Re: CSELR - response to Environmental Impact Statement

I wish to voice my opposition for the proposed design of the CBD and South East Light Rail project (CSELR) as described in the Environmental Impact Statement (EIS) dated November 2013. Specifically, I do not agree with the proposal for a surface route along Devonshire Street as stated in the EIS document.

Illustration 1: Figure 1. Diagram of sanitary drainage. Diagram no. 356089

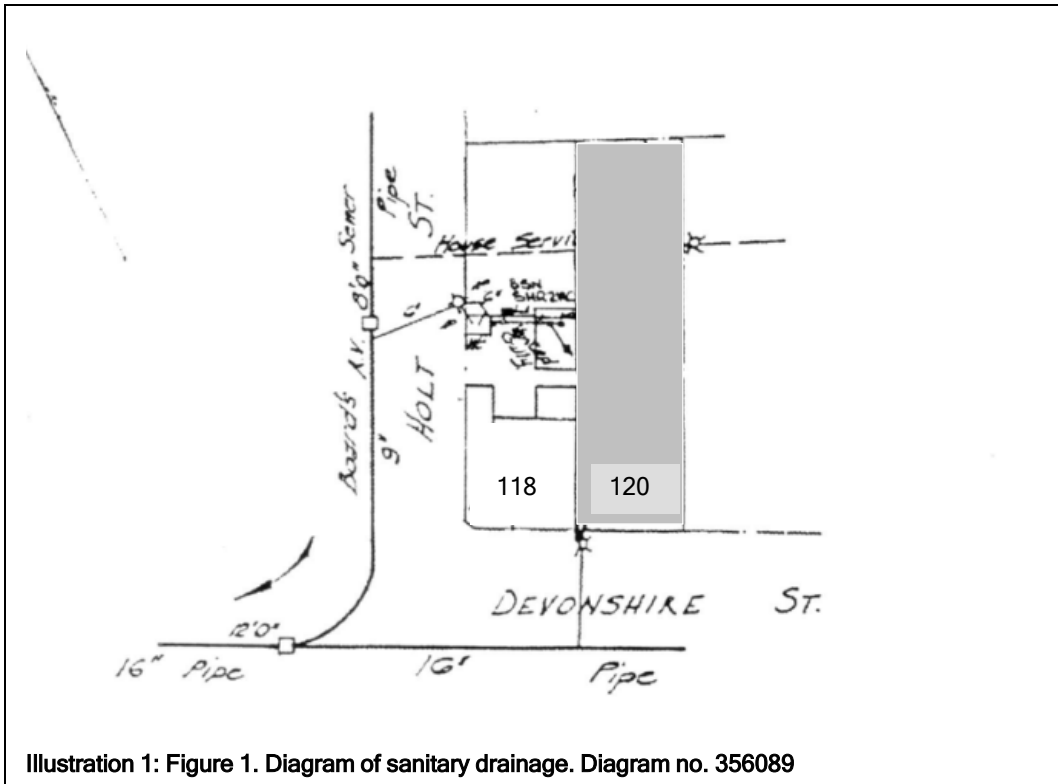
4. Loss of access to our connection to the sewer main on the opposite side of Devonshire Street.

The Private Clinic’s connection to the sewer main lies beneath Devonshire Street on the opposite (Southern) side of the road. Any future maintenance or repair of this connection or of the house line requires the excavation of the road surface on Devonshire Street which would be impossible once rail lines are installed .

On two occasions since 2003, this sewer line has required servicing. On the first occasion, the road surface required excavation to repair damage caused by a Sydney Water contractor. On the most recent occasion, the house connection was re-lined, however this will not be an option for any future repairs.

- If the surface route along Devonshire Street proceeds, re-route our sewer connection to an alternate connection point on the sewer in Holt Street.
